North Campus Faculty Housing Phase II  
Project No. FM110407L/986315

**Addendum No. 6**

ADDENDUM NUMBER 6  
to the  
CONSTRUCTION DOCUMENTS

**BUILDING 600A: REVERSE SECTIONS**

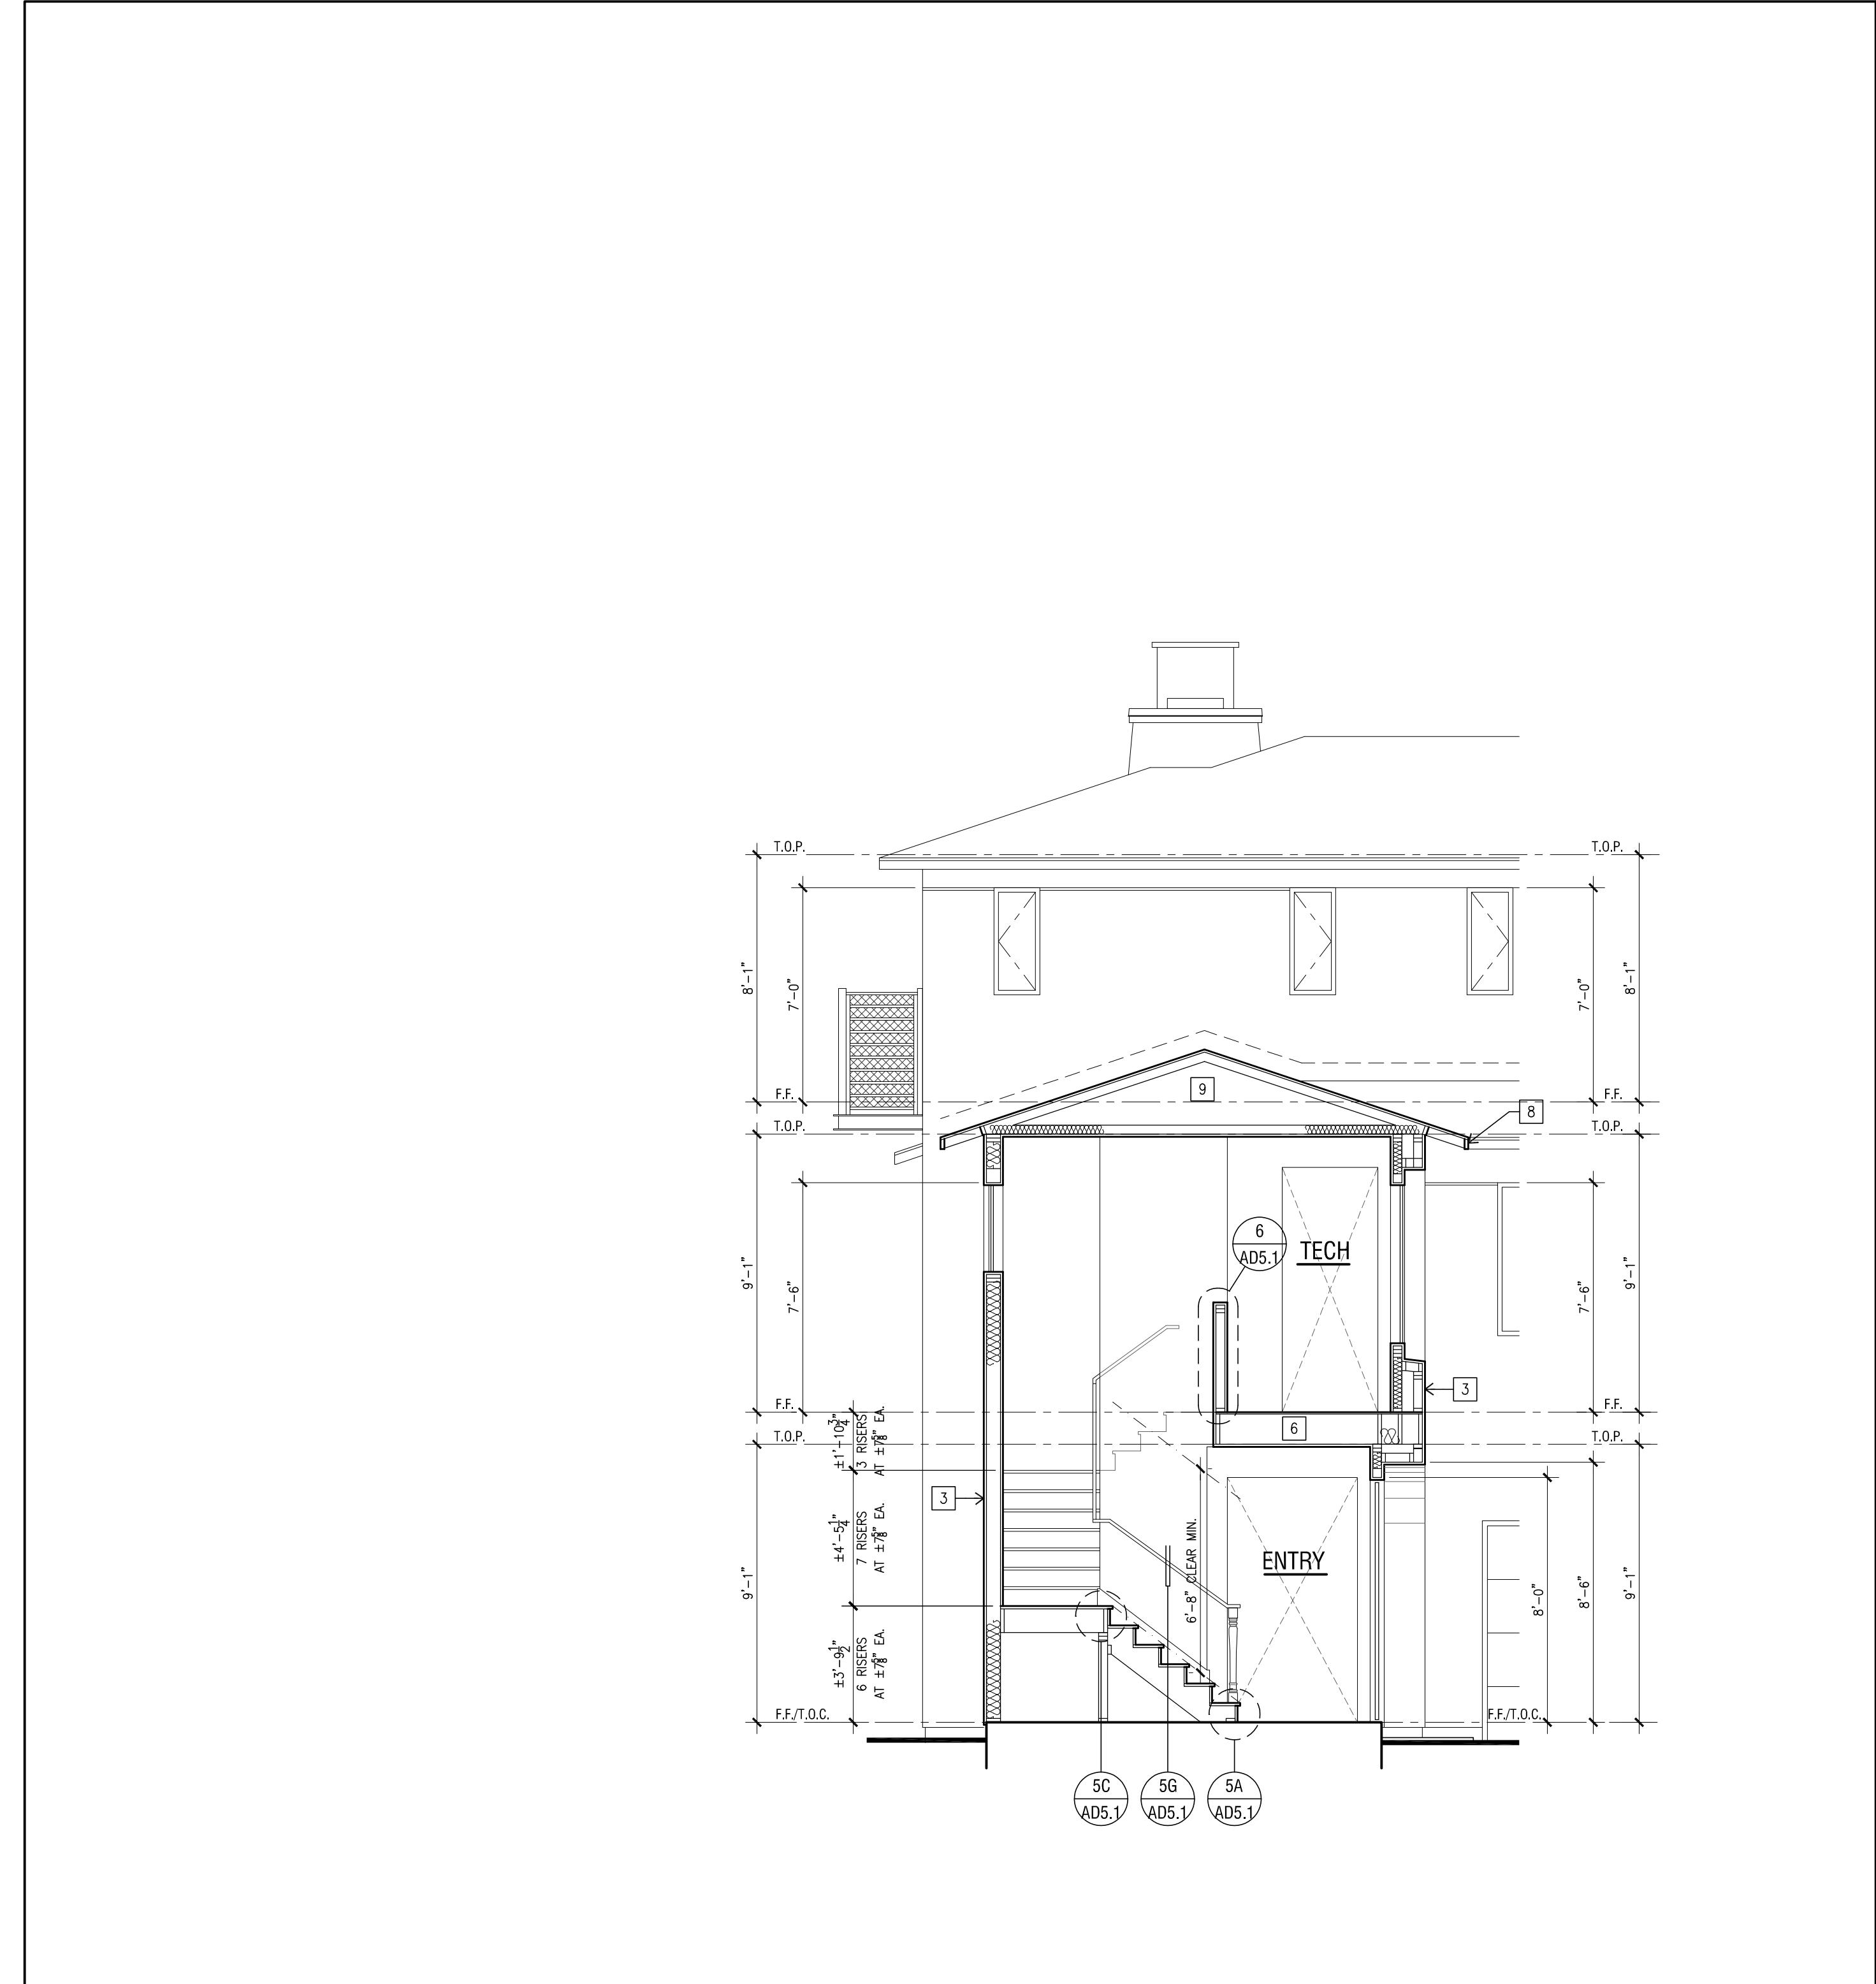
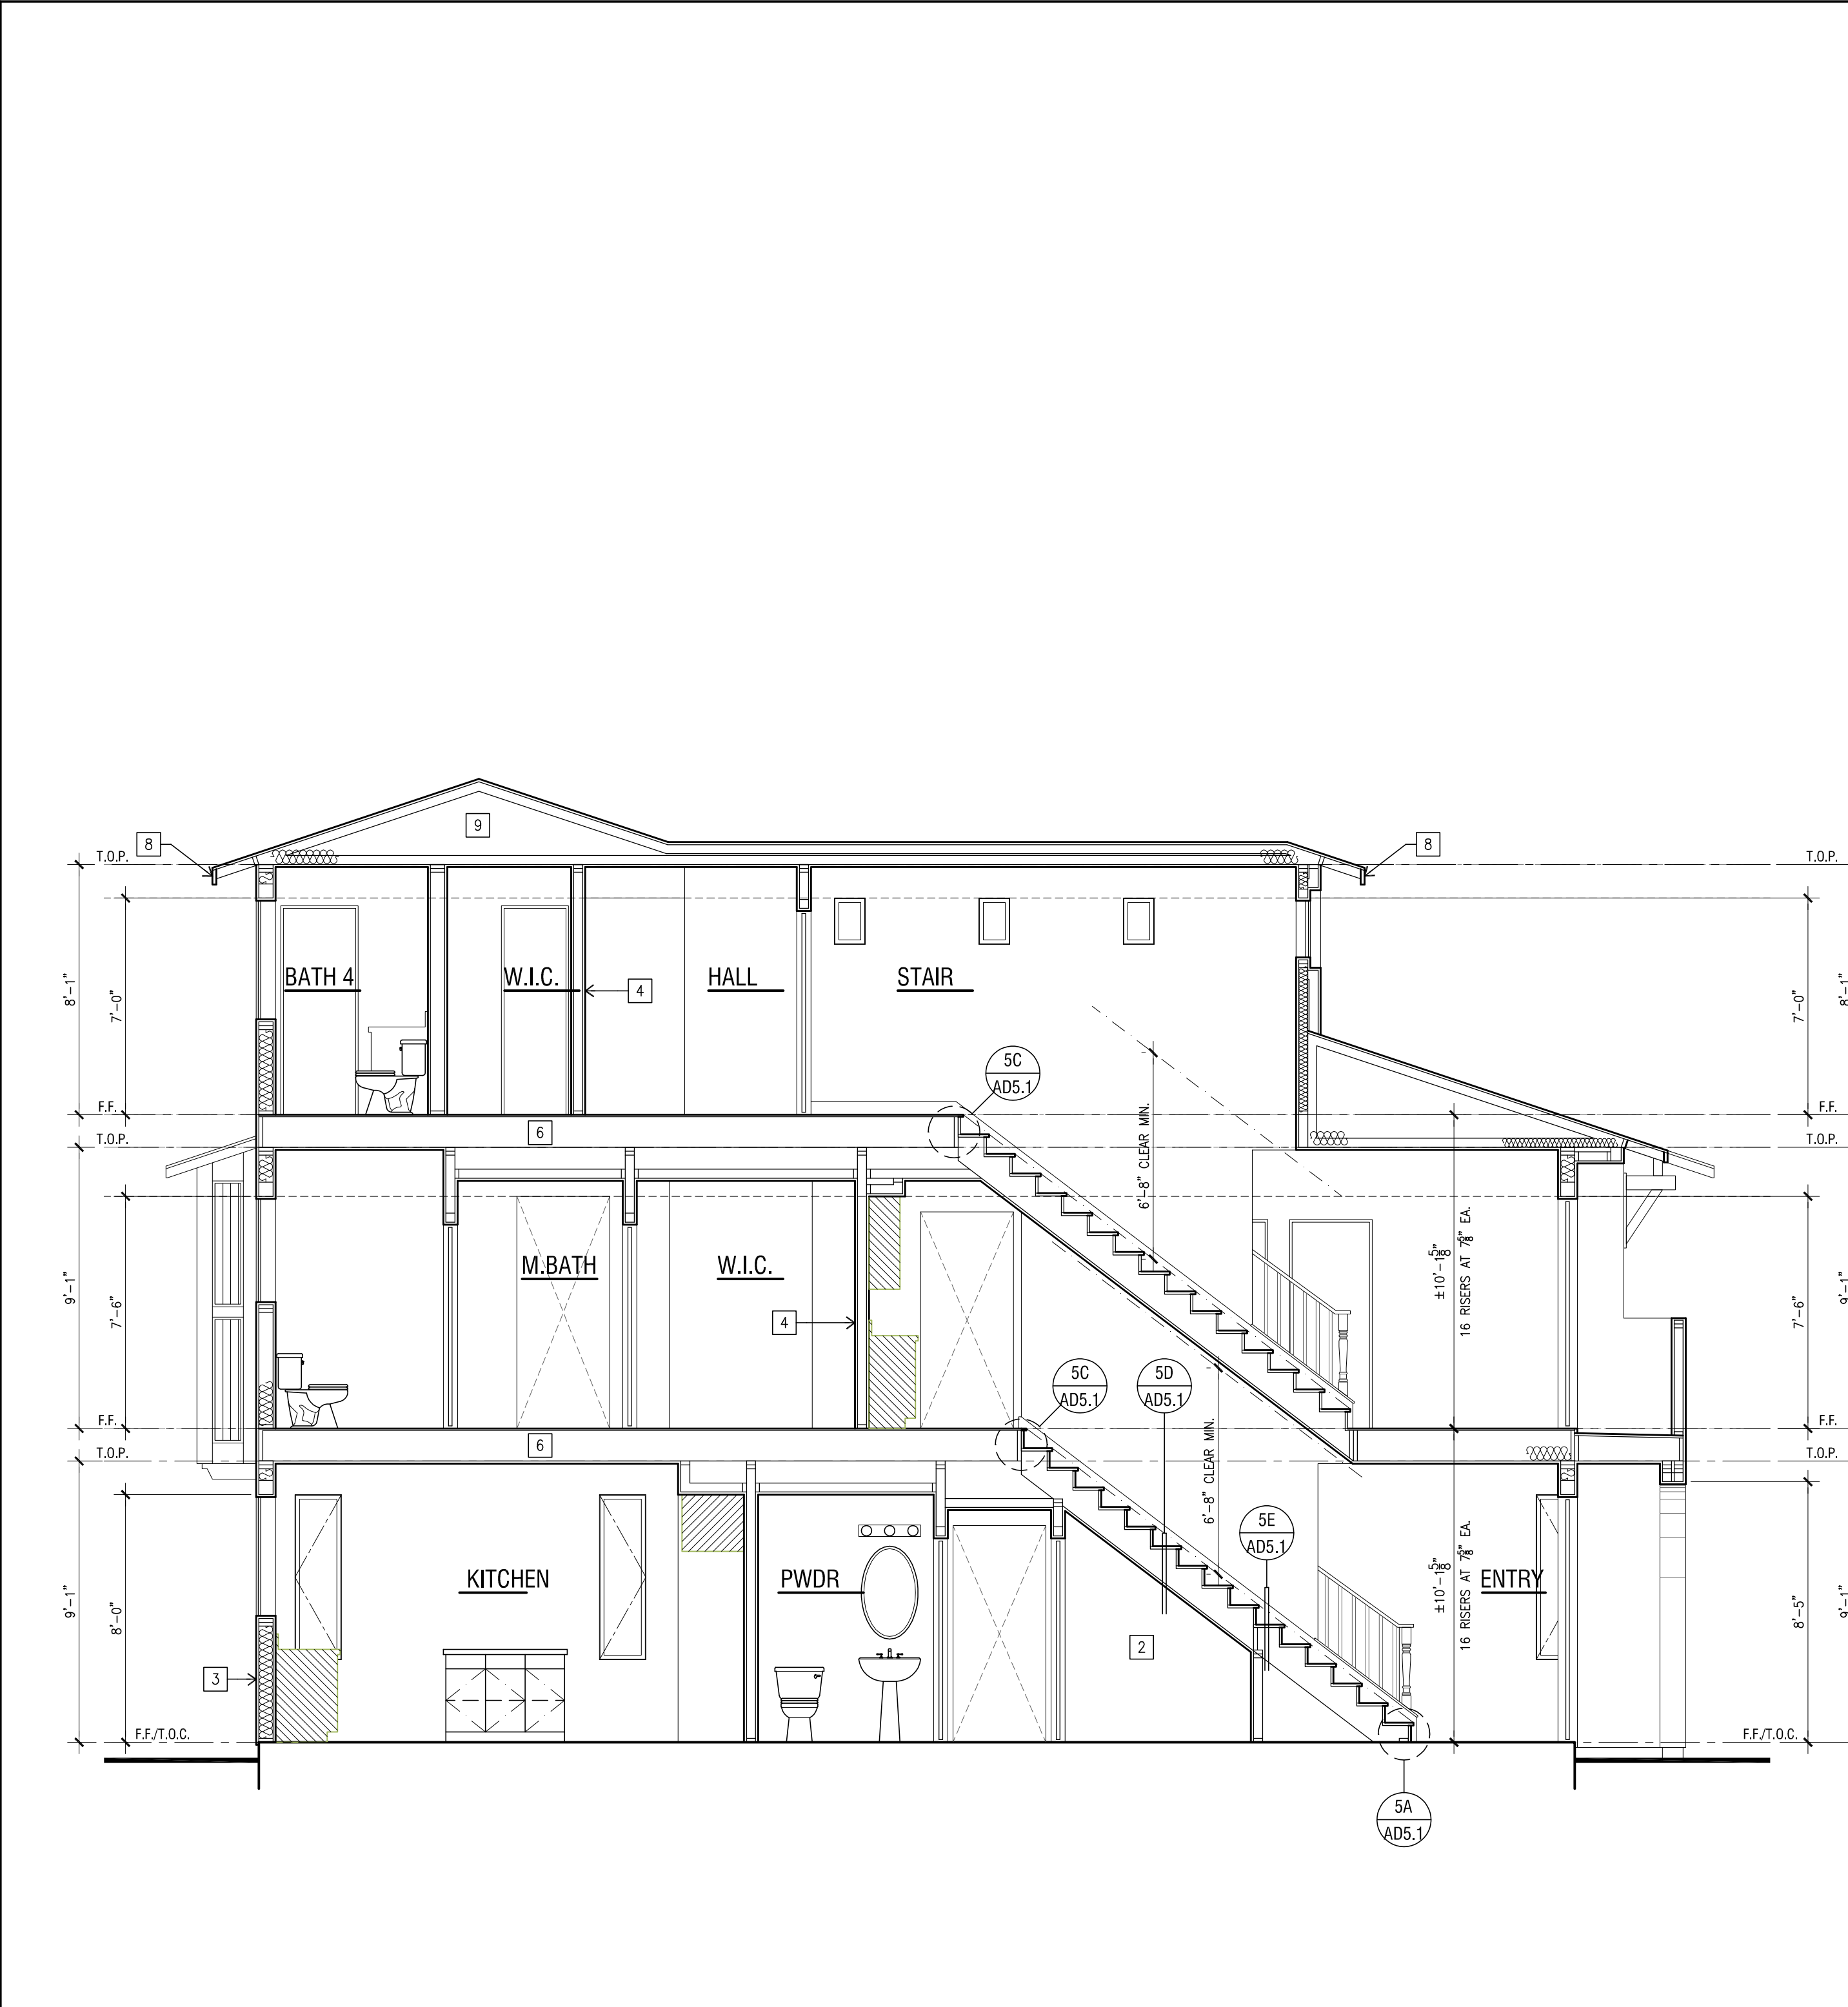
Sketch 5 of 8	Building 600A: Reverse: Sections
Sketch 6 of 8	Building 600B: Sections
Sketch 7 of 8	Building 700A: Sections
Sketch 8 of 8	Building 700A: Reverse: Sections
